Access Compliance Report Public Rights-of-Way (Curb Ramps)

Main Street: DAWNWOOD Cross Street: EARLYWOOD Location: SE

ADA ID: RPRK211025121147 Ramp Type: Type 4 - Parallel Initial Pass/Fail: Fail Overall Compliance: No Severity Score: 5

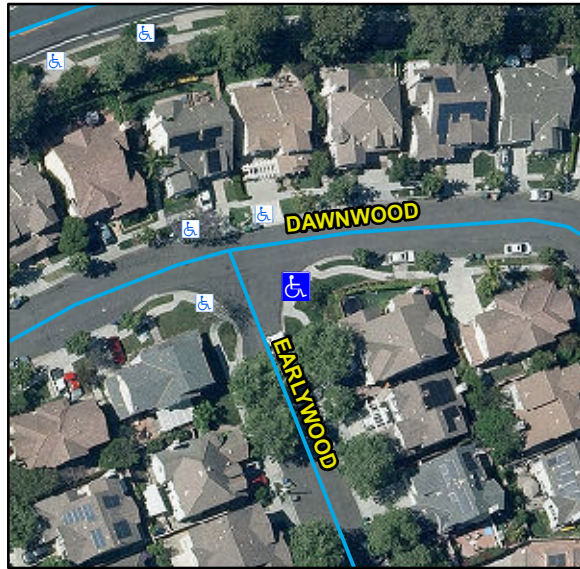
R204.3, R304.5.1, R304.5.3, STD 1115

Remove & Replace Curb Ramp With Two New Directional Ramps or Equivalent.
